**PLANNING COMMISSION
MEETING AGENDA
REGULAR MEETING**

5. PUBLIC HEARING - PRELIMINARY SITE PLAN REVIEW (SP JPLN2021-0028) - Proposed Golden Villas One Family Residential Cluster, South side of Square Lake, West of Dequindre (PIN 88-20-12-200-031 & 88-20-12-200-035), Section 12, Currently Zoned R-1C (One Family Residential) District

6. PRELIMINARY SITE PLAN REVIEW (SP JPLN2022-0002) – Proposed Norton and Quill Site Condominium, Northwest corner of Norton Street and Quill Creek Drive (PIN 88-20-03-251-043 & 88-20-03-251-044), Section 3, Currently Zoned R-1B (One Family Residential) District.

Project Name:	Golden Villas
Plan Date:	February 28, 2022
Location:	South of E. Square Lake, west of Dequindre
Zoning:	R-1C, One-family Residential District
Action Requested:	Preliminary Site Condominium Cluster Approval
Required Information:	Deficiencies noted.

DRAWING TITLE
PRELIMINARY SITE PLAN

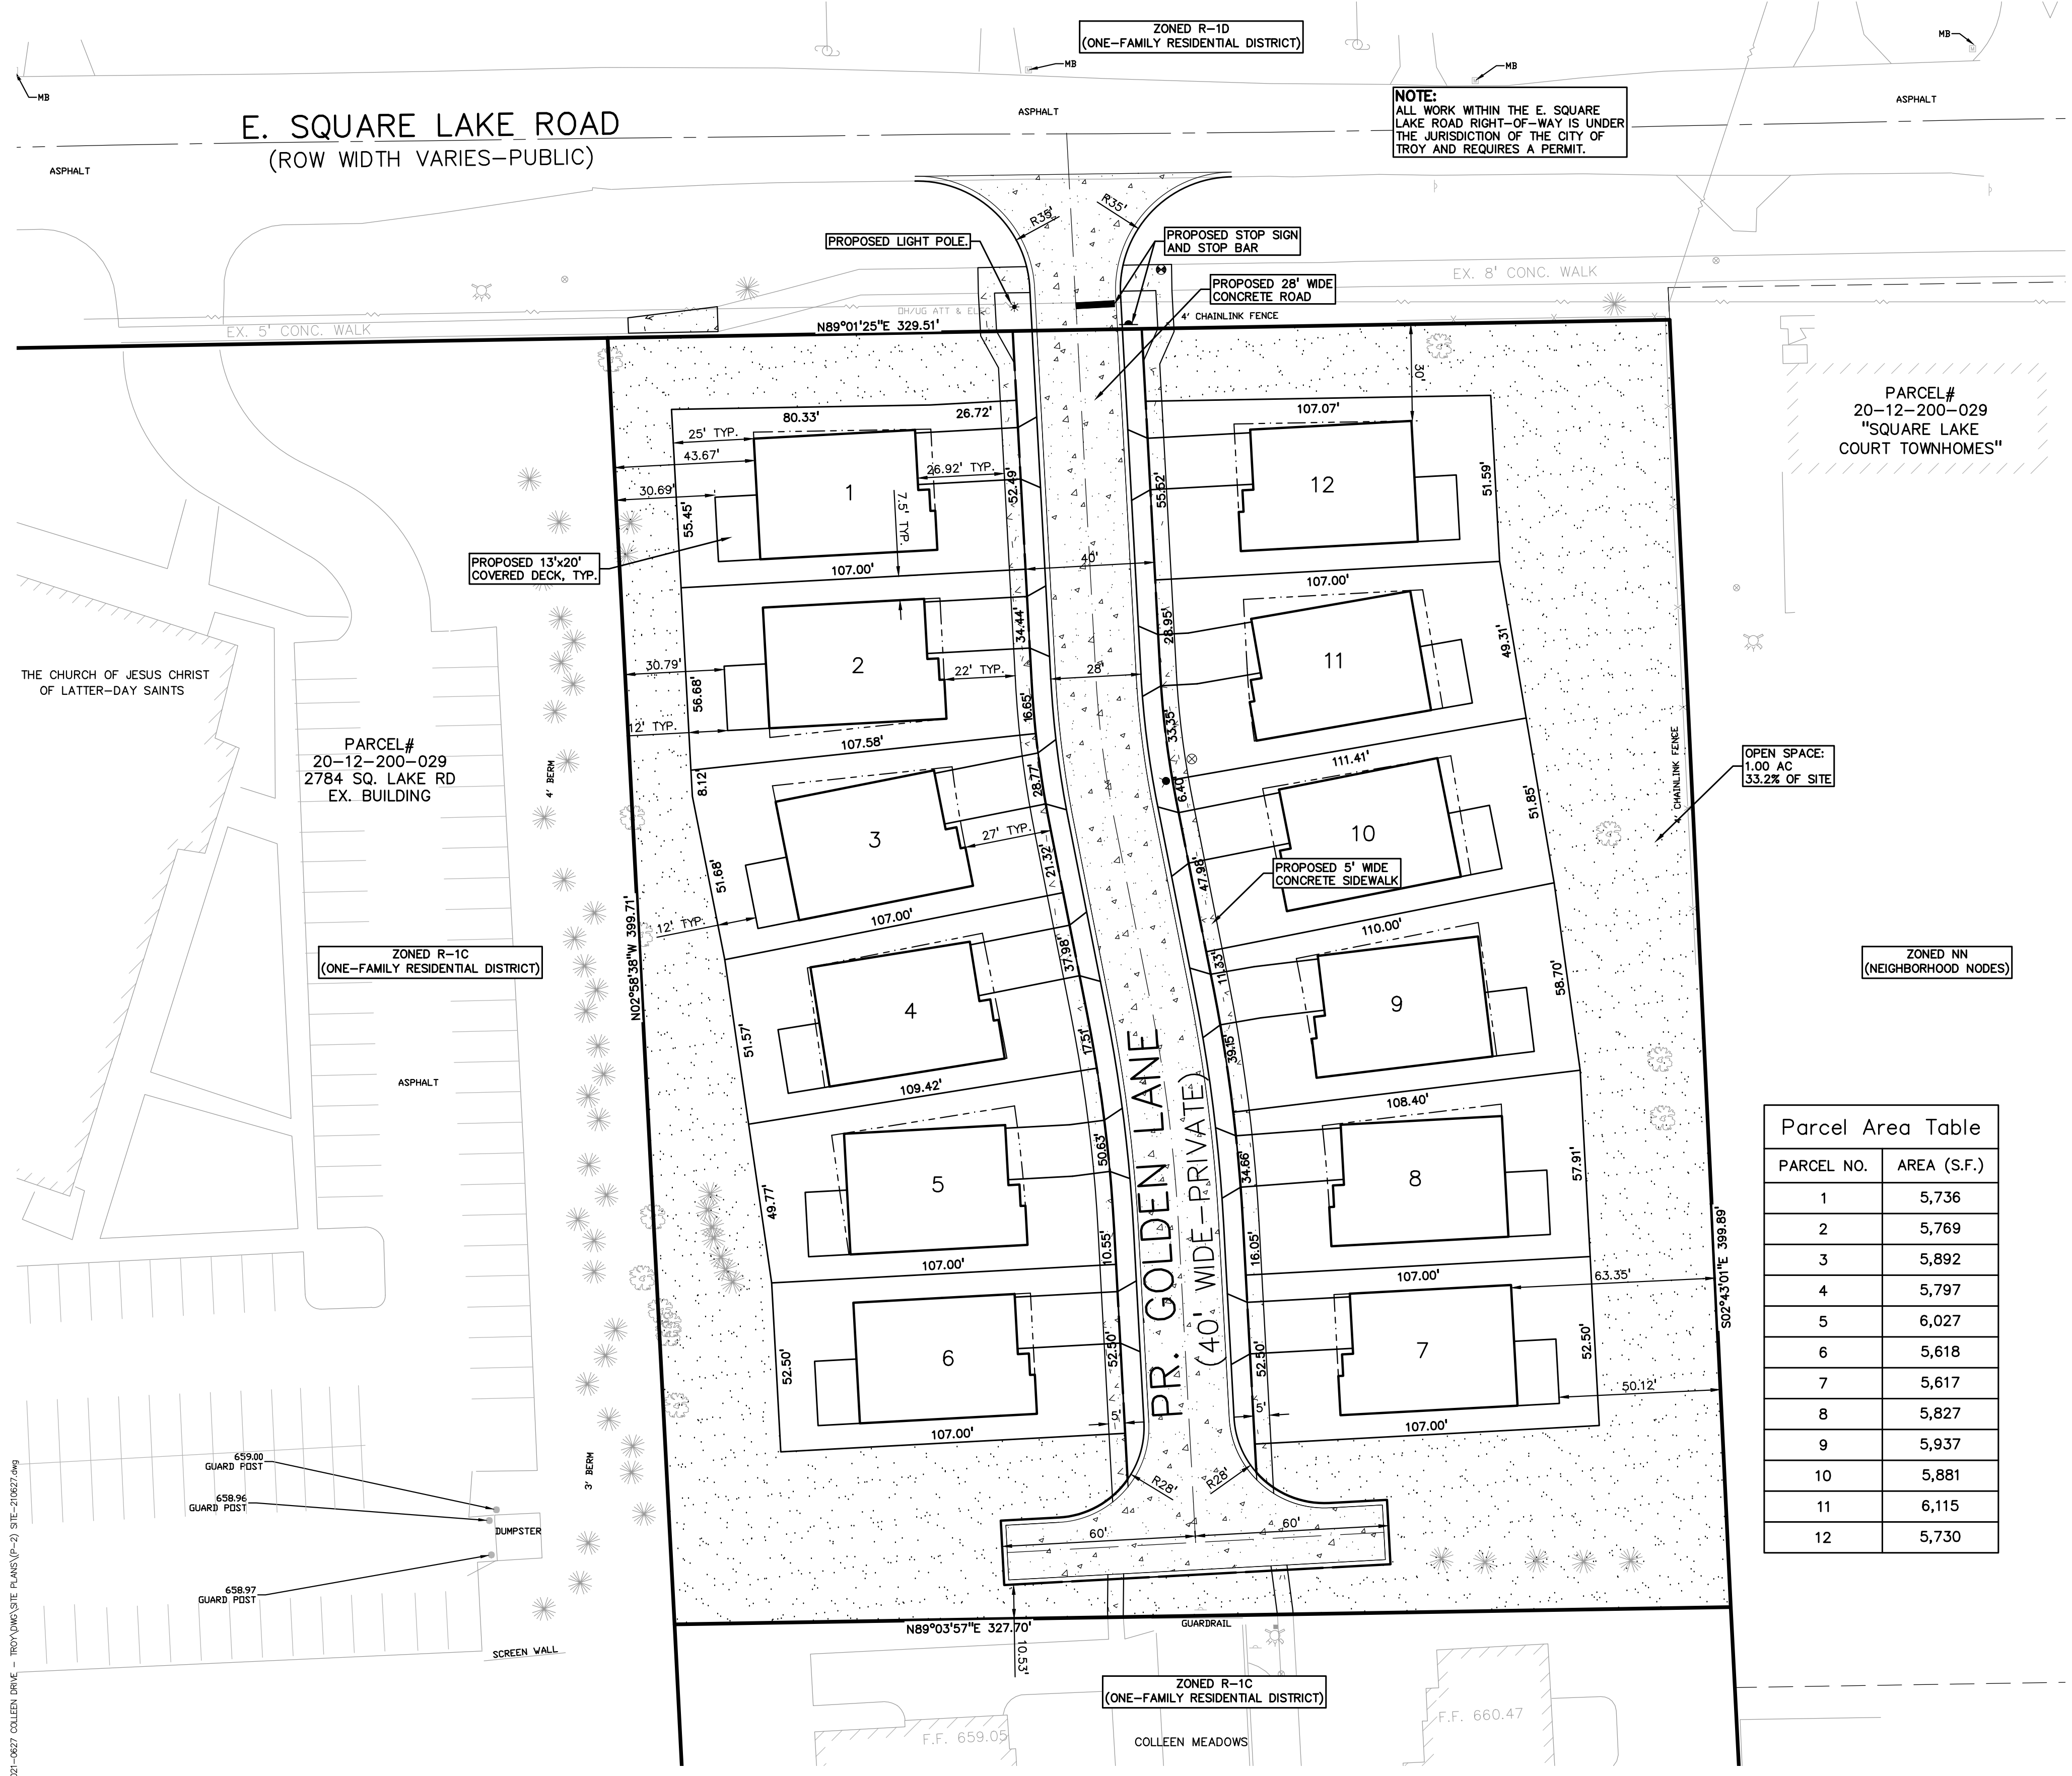
The site is 3 acres, and the applicant is proposing to reserve 1.0 acres for common open space, or 33% of the total site. Open space is provided within an open space collar around the northern, western, eastern, and southern property line. The open space collar ranges from 13-feet in depth along the northwest portion of the site, 50+ feet along the eastern property line, and 10-feet along the southern property line. As part of the review, the Planning Commission is to consider and make a recommendation to City Council if the layout and open space plan meets the intent and standards of the Cluster provision and has the applicant creatively designed the site to either preserve significant natural resources (trees, wetland, and floodplain) or provide quality open space.

- Applicant is seeking following relief:
 - Decks encroaching 15-foot into the required 25-foot rear yard
 - Lots 1-3 encroach up to 10-feet into the required 40-foot perimeter setback
- Provide additional housing elevation options
- Provide twenty (20) additional trees along Square Lake Road.

DRAWING TITLE
TREE PRESERVATION PLAN

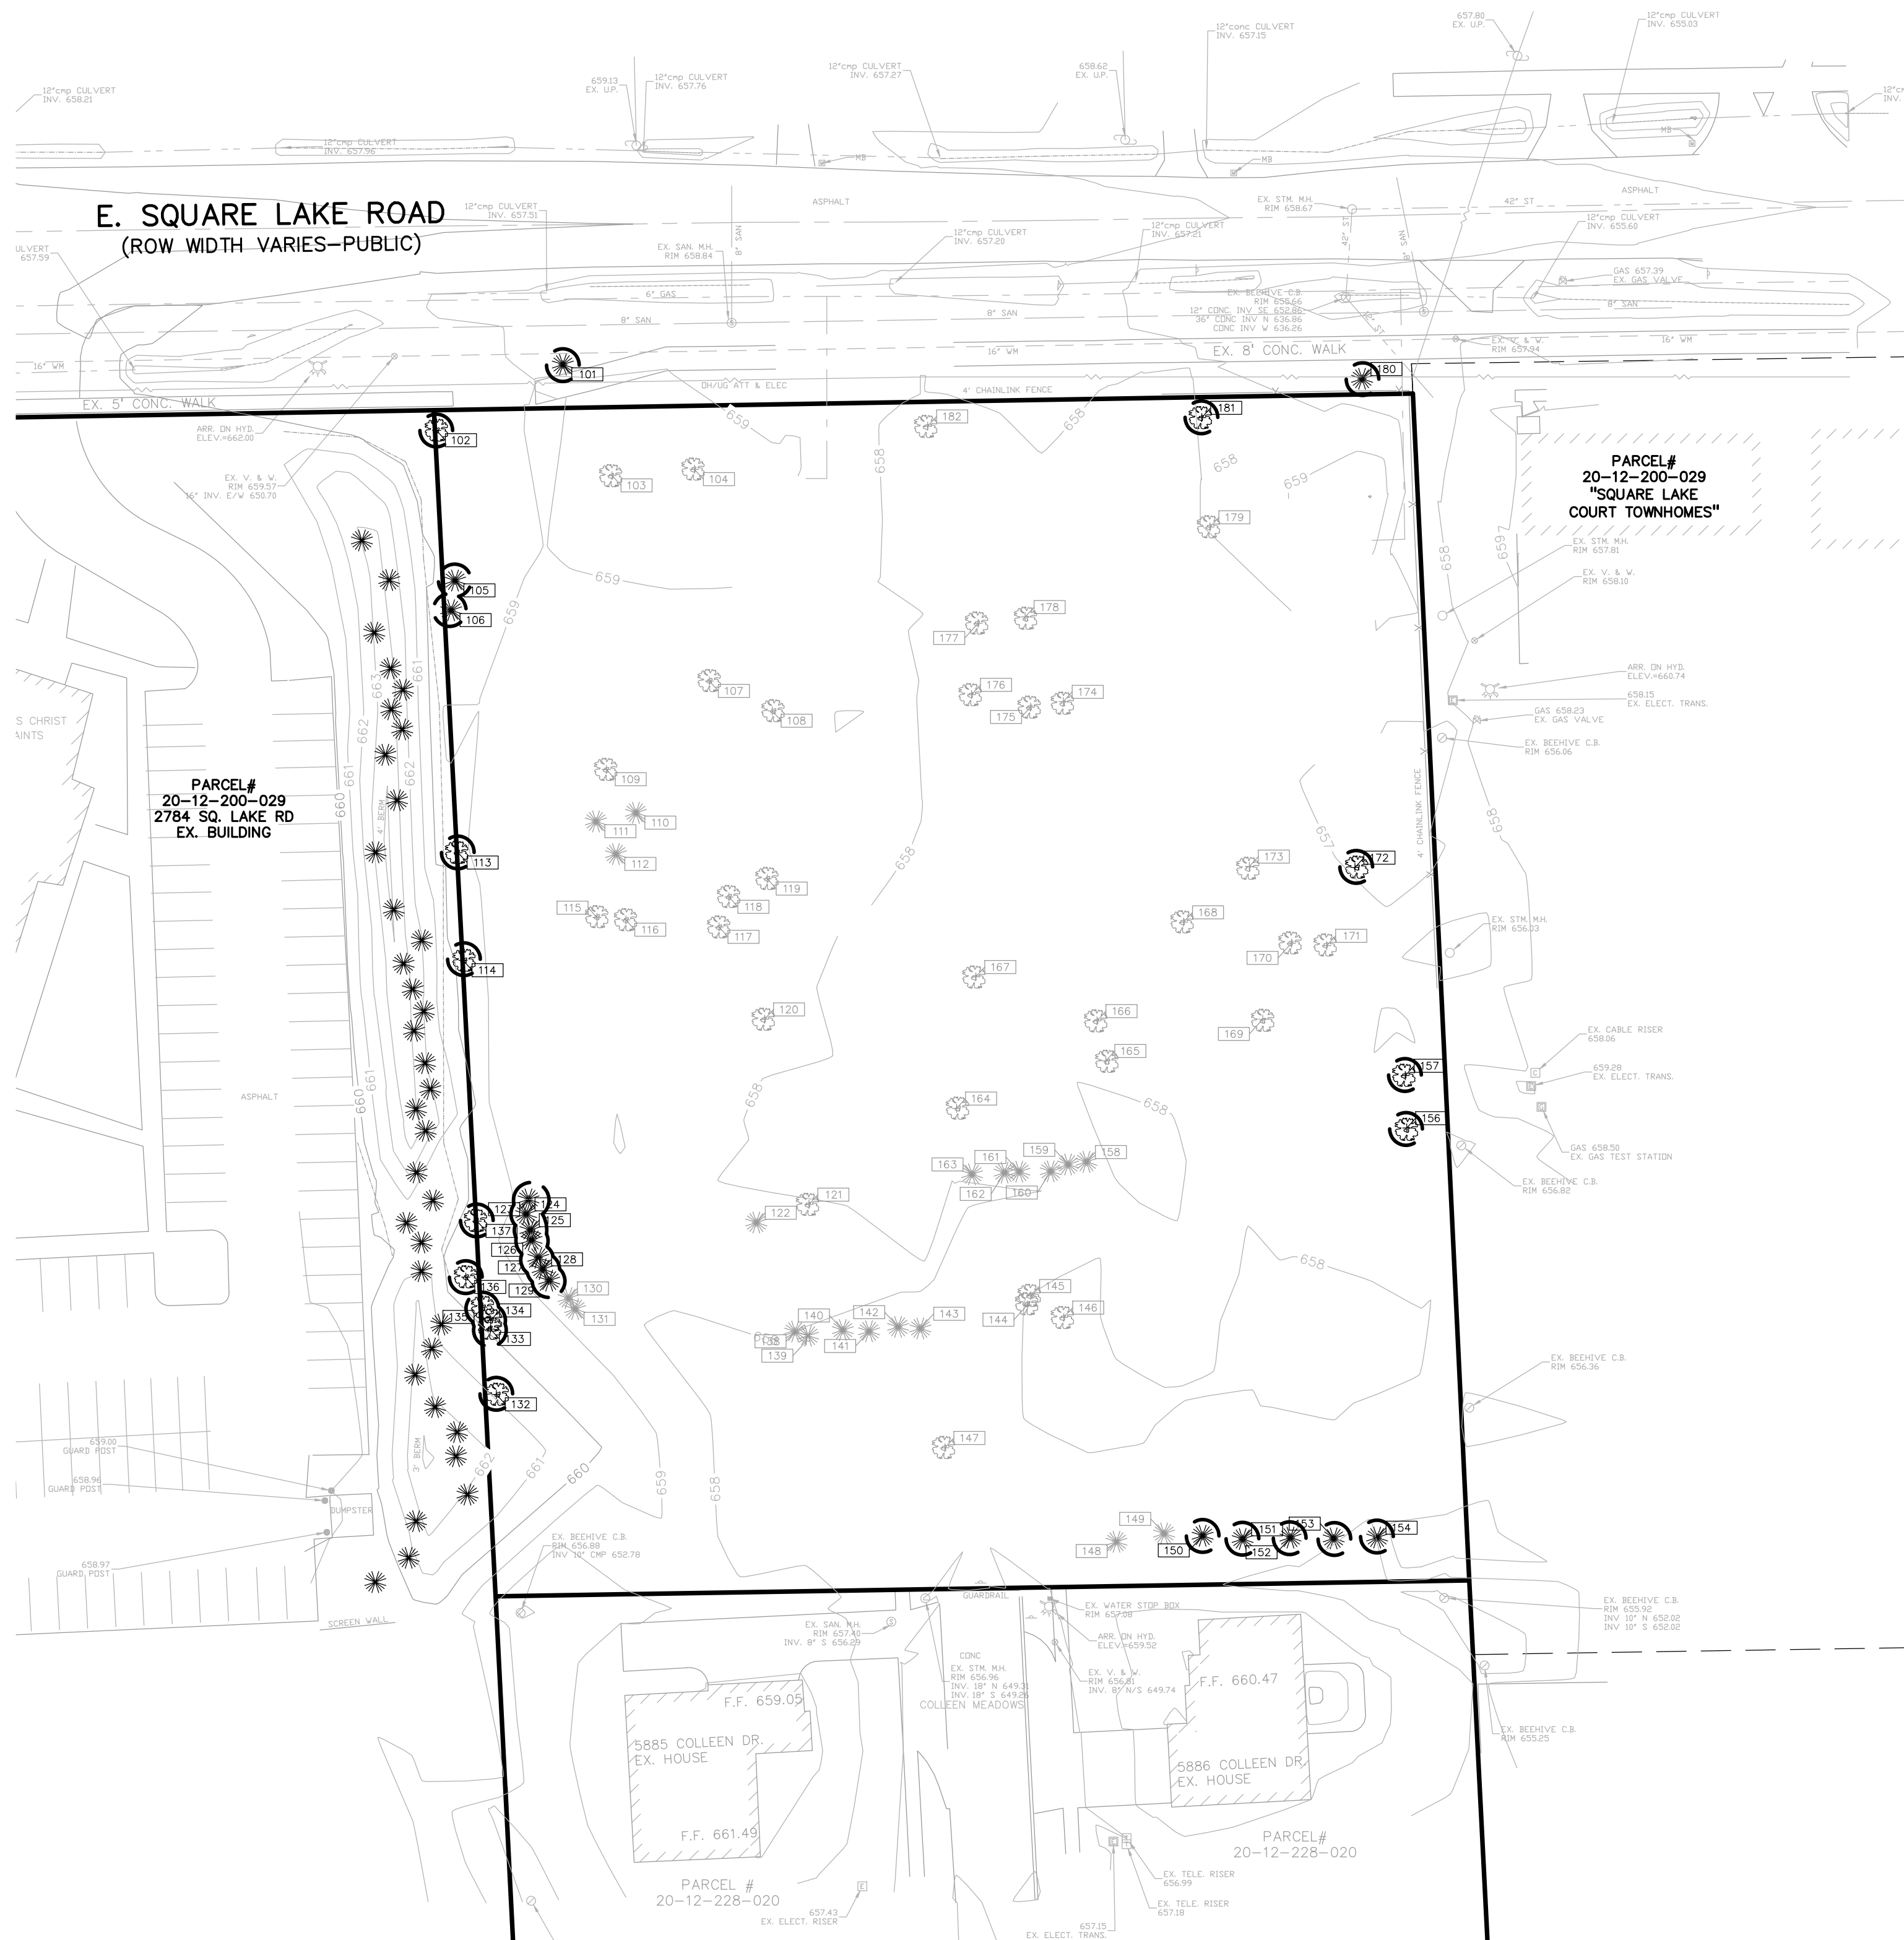
1. Applicant shall provide additional housing elevation options.
2. Applicant shall provide twenty (20) additional trees along Square Lake Road.

Items to be Addressed: Provide twenty (20) additional trees along Square Lake Road.
